Bid Waiver Form

**Cost Estimate - SCS Engineers
Rowe - Vapor Mitigation
SCS Project No. 25213053.06**

Subject: PECFA Change Order Request – Vapor Mitigation
Former Rowe Property
217 Main Street, Cambridge, Wisconsin
BRRTS #: 03-13-558384 and 03-13-002673 (closed)
PECFA #: 53523-9999-17

RE: **Public Bidding Deferred – Cost Cap Approved**
PECFA # 53523-9999-17-A DNR BRRTS # 03-13-002673
Rowe Pottery Works-ROW, 217 Main St (CTH PQ ROW), Cambridge

Site Plan with Proposed Vapor Mitigation Features

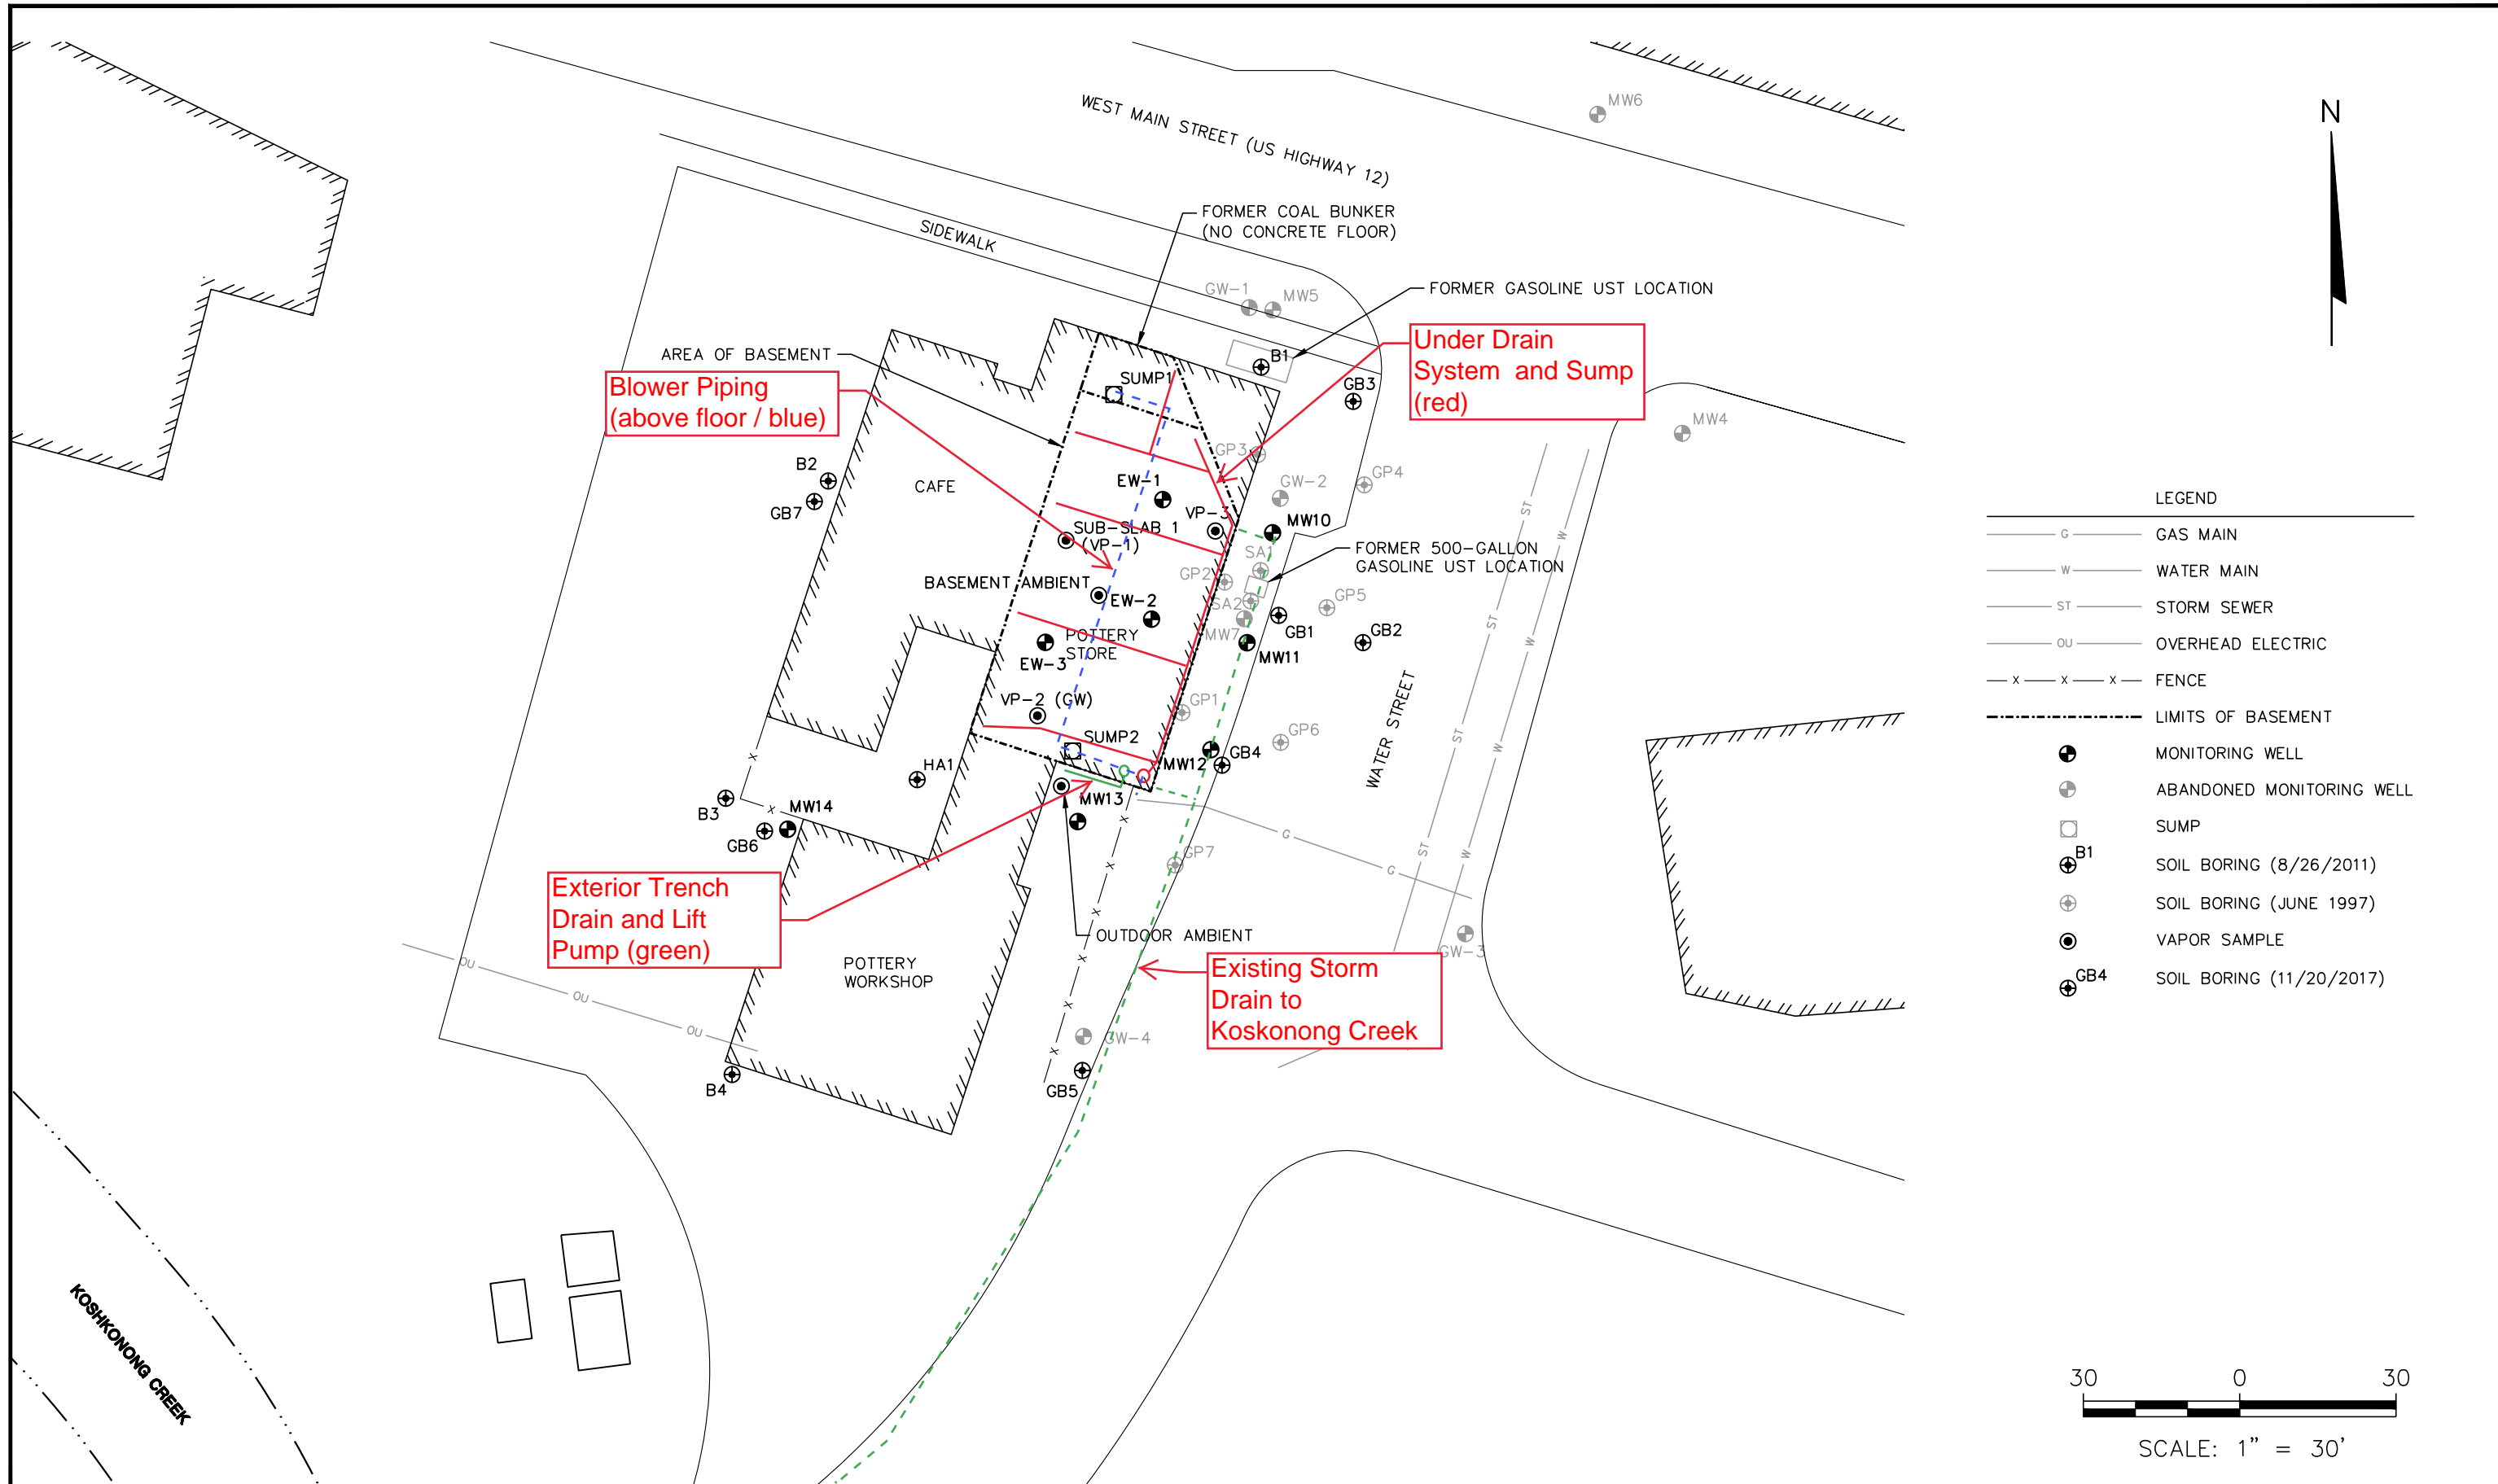
The under drain pipes will be connected to a dedicated, sealed sump that is connected to an externally-vented depressurization blower. The layout of these features is shown on **Figure 2**. The initial groundwater discharge from the underdrain system will be tested and collected for off-site disposal. If the contaminant concentrations after initial pumping from the underdrain are suitable for surface water discharge without further treatment, then this sump will be connected to the storm sewer under a Wisconsin Pollutant Discharge Elimination System (WPDES) permit for discharge to Koskonong Creek. We anticipate that as the cone of depression created by the underdrain expands, the hot spot concentrations under the floor will be diluted to levels below permit criteria for benzene, naphthalene, total benzene, toluene, ethylbenzene, and xylenes. Furthermore, as groundwater flows through the emplaced BAM, the dissolved petroleum will be absorbed by BAM and become immobilized pending biodegradation within the BAM. With the underdrain functioning, the blower on the sump will be able to propagate negative pressure into the dewatered area underneath the floor slab and prevent the migration of vapor into the basement.

If the discharge from the underdrain does not meet surface water quality criteria, the underdrain sump will not be pumped to the storm drain. Instead we will proceed directly to Phase 2. A dimpled polyethylene drainage sheet will be placed on the existing floor to allow for depressurization of a thin zone underneath the vapor barrier that is laid on top of the drainage sheet. Sump 2 and a reconstructed Sump 1 that is sealed into the new concrete floor to be installed in the “coal room” will collect water that makes its way into the basement and accumulates underneath the vapor barrier. The drainage sheet underneath the vapor barrier will be depressurized using the blower via pickup points at the two sumps and at two additional intermediate pickup points installed into the drainage sheet. Water entry into the basement will be minimized by creating a solid floor in the coal room, sealing cracks and openings in the basement wall against water infiltration, and capturing surface drainage water currently flowing in under the basement ramp door with a trench drain installed outside the door opening.

- Coordinate with contractors and secure local permits, if any are necessary.
- Remove concrete for a width of approximately 1.5 feet in the areas of the proposed drain trenches.
- Provide positive ventilation in the basement when the floor is open and when engine-powered equipment is in use.
- Excavate soil from below the floor in the trenches to an average depth of no more than 1.5 feet and excavate soil in the coal room to accommodate the thickness of a concrete floor and gravel drainage layer.
- Install 4-inch diameter drain pipe in the trenches, sloped to a collection sump at the southeast corner of the basement. Backfill the trenches with clear stone for drainage.
- Re-install a fully lined sump in the coal room to replace unlined Sump 1.

- Replace the concrete floor above the trenches and install a new floor in the coal room.
- Install a trench drain across the bottom of the basement access ramp. Connect this drain to its own lift pump with a discharge to the storm drain along Water Street or an alternate surface discharge location.

- Seal existing cracks and openings in basement walls with patching mortar and/or injected epoxy.
- Seal the underdrain sump and connect it to an externally vented “radon” blower.

- Install Delta-FL or similar dimpled poly “drainage” sheet and tape seams. Ensure continuity from the sheet to Sumps 1 and 2.
- Add vapor depressurization pickup points to Sumps 1 and 2 and seal two additional pickup pipes into the drainage sheet with flanged connections at two intermediate locations.

- Install Stego 15 mil vapor barrier or similar product above the drainage sheet, seal penetrations, and seal the vapor barrier to the wall.
- Connect pickup points to blower and verify negative pressure between the floor and vapor barrier with blower operating.
